From: [Ritzen, Brenda](#)
To: [Thalia Rivas](#); [Olvera, Brandon](#)
Subject: RE: Revision: Permit 117239 Address: 2514 Cypress Gardens Spring Branch Tx
Date: Tuesday, April 23, 2024 8:23:00 AM
Attachments: [image001.png](#)

Permit of Authorization to Construct an On-Site Sewage Facility Permit Valid For One Year From Date Issued

Permit Number: 117239
Issued This Date: 03/15/2024
This permit is hereby given to: Zerep Enterprises LLC

Drip Tubing System

OWNER: ZEREP ENTERPRISES LLC
LEGAL DESCRIPTION: LOT 57, BLOCK 103, CYPRESS LAKE GARENS SUBDIVISION, WESTERN SKIES SECTION
ADDRESS: 2514 CYPRESS GARDENS BLVD SPRING BRANCH TX 78070
PREPARED BY: THALIA RIVAS R.S 5067 SCALE: 1" = 25'

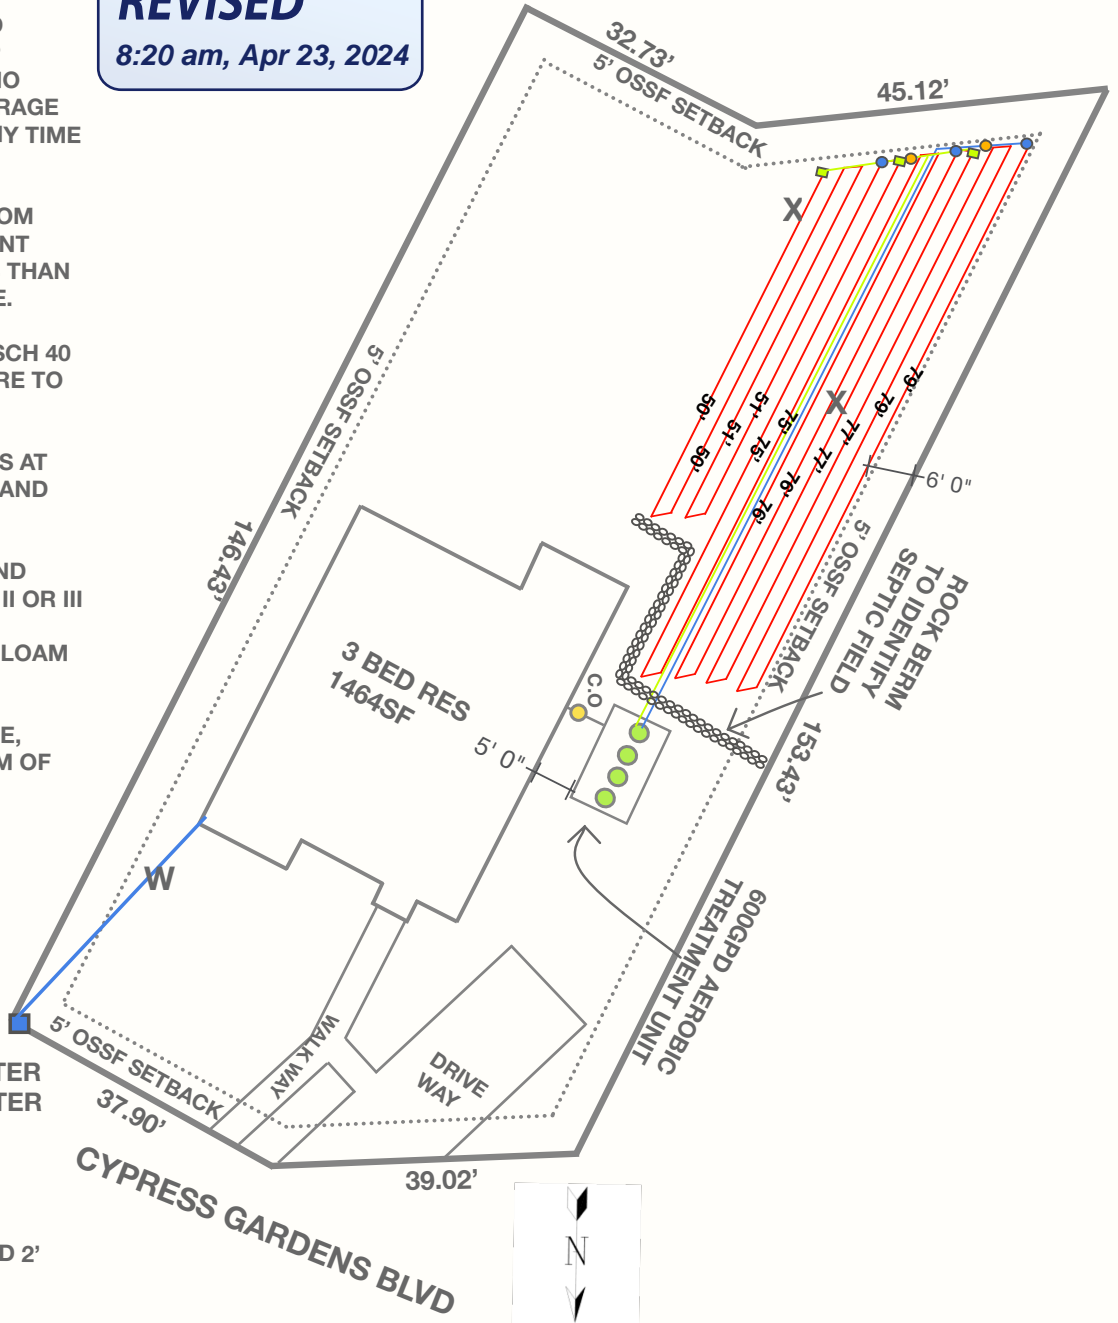
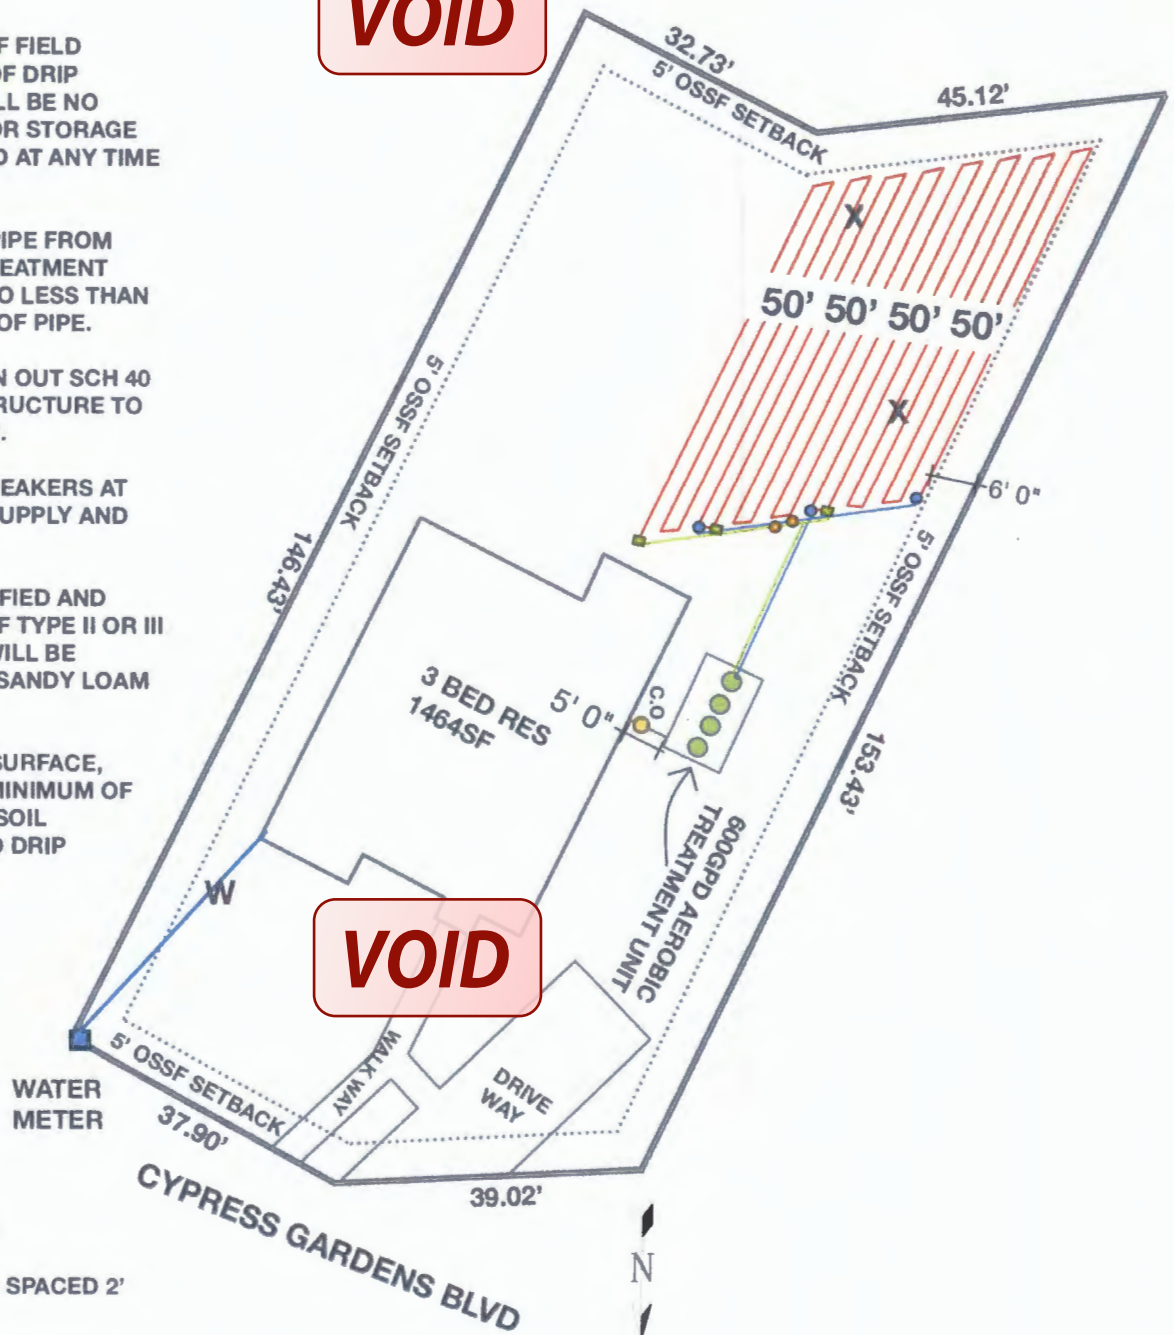
Will the rock berm have any impact on the septic line running underneath it?

INSTALL 1632SQFT OF FIELD TUBING USING 816' OF DRIP TUBING. THERE SHALL BE NO PARKING, DRIVING, OR STORAGE ON THE SEPTIC FIELD AT ANY TIME FOR ANY REASON.

INSTALL:
2 LINES @ 79' EACH
2 LINES @ 77' EACH
2 LINES @ 76' EACH
2 LINES @ 75' EACH
2 LINES @ 51' EACH
2 LINES @ 50' EACH

816' OF DRIP TUBING SPACED 2' APART.

INSTALL 1600SQFT OF FIELD TUBING USING 800' OF DRIP TUBING. THERE SHALL BE NO PARKING, DRIVING, OR STORAGE ON THE SEPTIC FIELD AT ANY TIME FOR ANY REASON.

INSTALL:
16 LINES @ 50' EACH

800' OF DRIP TUBING SPACED 2' APART.
